THE CORPORATION OF THE CITY OF COURTENAY

MEMORANDUM

To: Chris Marshall, Director of Development Services
From: Mike Grimsrud, Planner II
Subject: Application for Development Permit at 366A Clubhouse Drive

To consider the issuance of a commercial development permit for a 28-unit motel development.

Schedule No. 1 – Site Plan

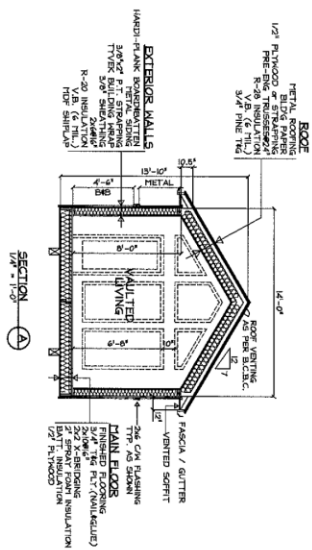
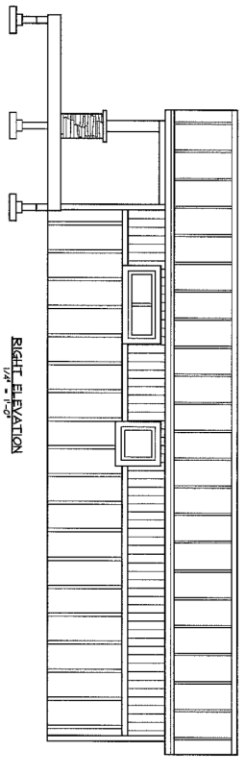
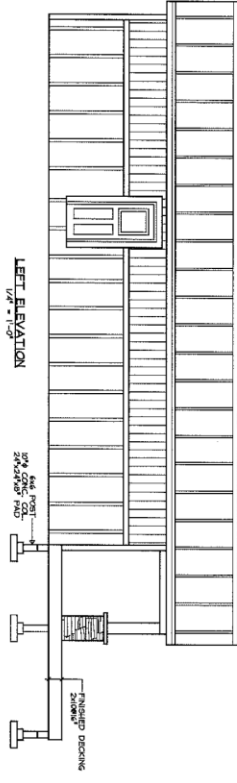
Staff Note:
5.5m
typical
parking
stall length

Staff Note:
Motel
units

1. The development shall be substantially consistent with the site plan shown in *Schedule No. 1*, by Koers & Associates Engineering Ltd., dated November 18, 2021;

Schedule No. 2 –Plans & Elevations

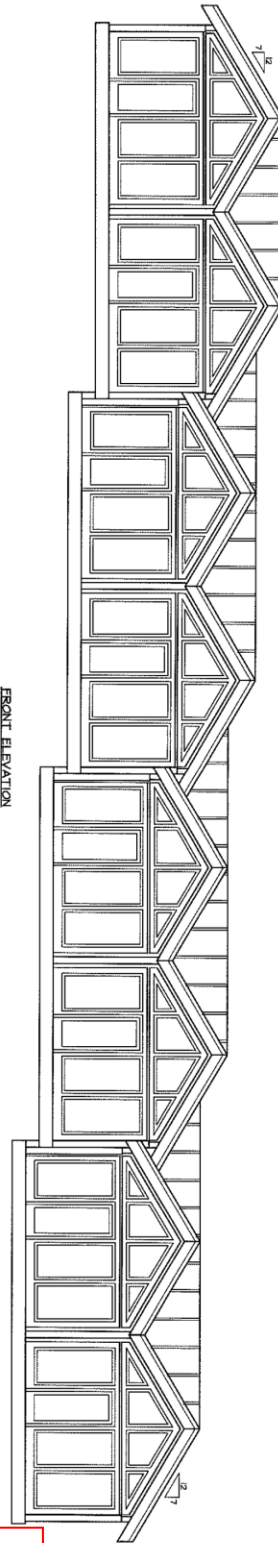
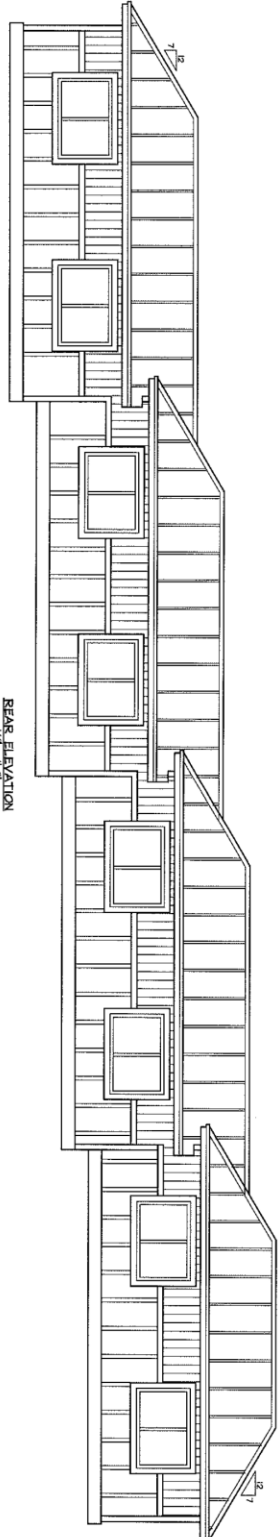
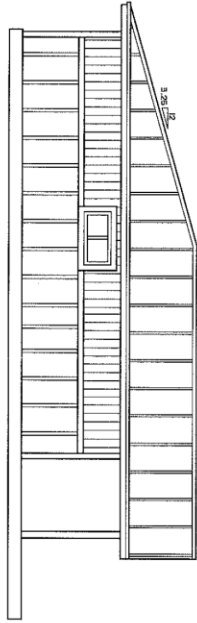
Staff Note:
4-plex motel

Staff Note: 8-unit building pictured to be separated into two 4-unit buildings

2. The development shall be substantially consistent with the building plans and elevations shown in *Schedule No. 2*, by D. Bell Designs, dated January 29, 2021, except that the 8-unit building will be divided into two 4-unit buildings;
